Office Action Summary

09/940,501

NONIN, KATSUYA

DETAILED ACTION

FIG. 1

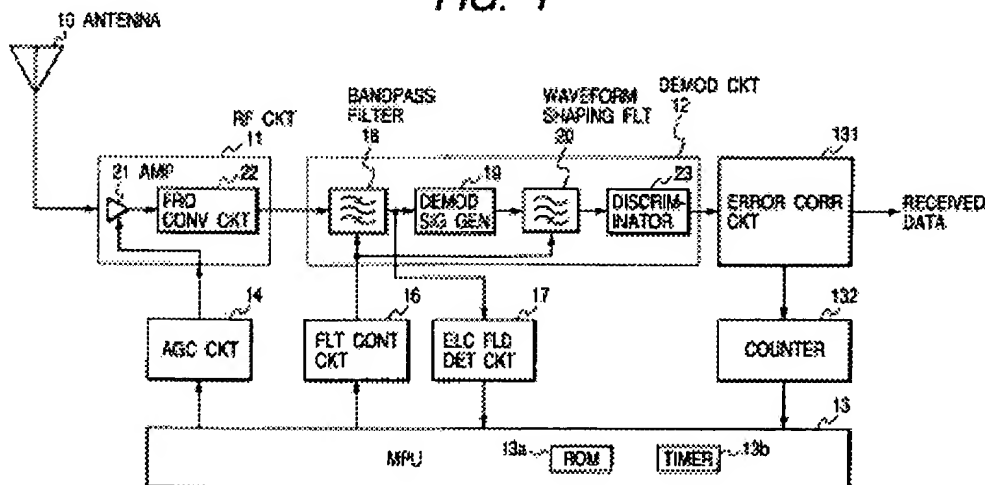
As per **Claim 1**, **Yoshida et al.** substantially all the limitations of the claimed error correction apparatus in Fig. 1 comprising: a receiving section configured to receive a signal; an amplifier section configured to amplify the received signal received

by the receiving section; an automatic gain control section configured to generate a control signal and to control a gain of the amplifier section based on the generated control signal,

so as to maintain the amplified received signal at a predetermined level; and a turbo decoder configured to execute an error correction process on the received signal to thereby output a decoding result of the executed received signal based on the generated control signal.

Not specifically described in detail in **Yoshida et al.** is the ECC being effected via Turbo coding means. **However Yoshida's block 131 performs ECC. Accordingly, Summers et al.** discloses '*SNR mismatch and online estimation in Turbo decoding*,' in an analogous art, wherein such techniques are described. {See **Summers et al.**, Id., Abstract.} **Therefore**, it would have been obvious to a person having ordinary skill in the art at the time the invention was made to modify the procedure in **Yoshida** by including therein *Turbo* coder means as taught by **Summers et al.**, because such modification would provide the procedure disclosed in **Yoshida** with a technique whereby "*performance near Shannon capacity limit is attainable with moderate decoding complexity*." {See **Summers et al.**, Introduction.}

FIG. 1

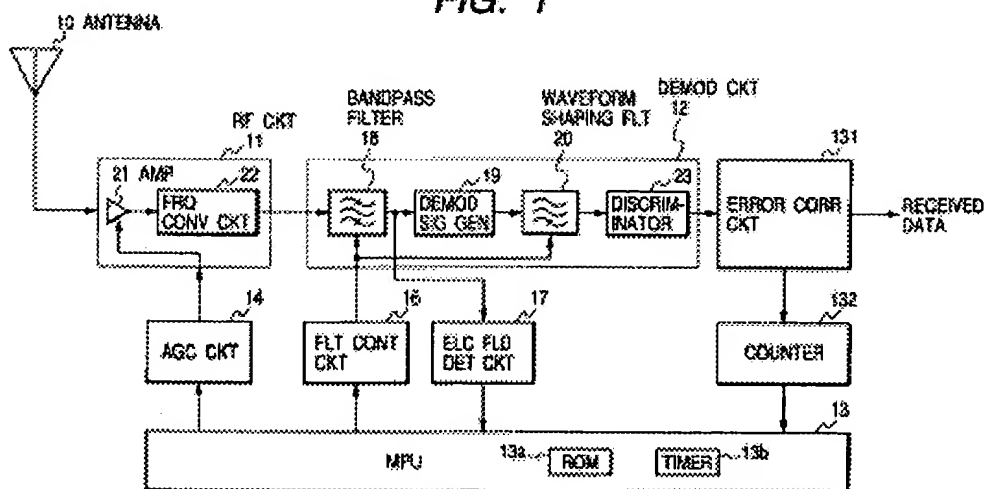
As per Claims 1-4, **Yoshida et al.** substantially all the limitations of the claimed error correction apparatus in Fig. 1 comprising: a receiving section configured to receive a signal; an amplifier section configured to amplify the received signal received

by the receiving section; an automatic gain control section configured to generate a control signal and to control a gain of the amplifier section based on the generated control signal,

so as to maintain the amplified received signal at a predetermined level; and a turbo decoder configured to execute an error correction process on the received signal to thereby output a decoding result of the executed received signal based on the generated control signal.

Not specifically described in detail in **Yoshida et al.** is the ECC being effected via Turbo coding means. **However Yoshida's block 131 performs ECC. Accordingly, Kumar** discloses '*In-band on-channel digital broadcasting method and system,*' in an analogous art, wherein such techniques are described. {See **Kumar, Id.**, Fig. 4: block 41 for concatenated coding, and "turbo" coding means; data storage means via look-up tables.} **Therefore**, it would have been obvious to a person having ordinary skill in the art at the time the invention was made to modify the procedure in **Yoshida** by including therein *Turbo* coder means as taught by **Kumar**, because such modification would provide the procedure disclosed in **Yoshida** with a technique whereby "Convolutional and/or block ECC coding, including combinations thereof (e.g. concatenated coding, and "turbo" coding) may be implemented." {See **Kumar**, e.g. Fig. 4: block 41.}
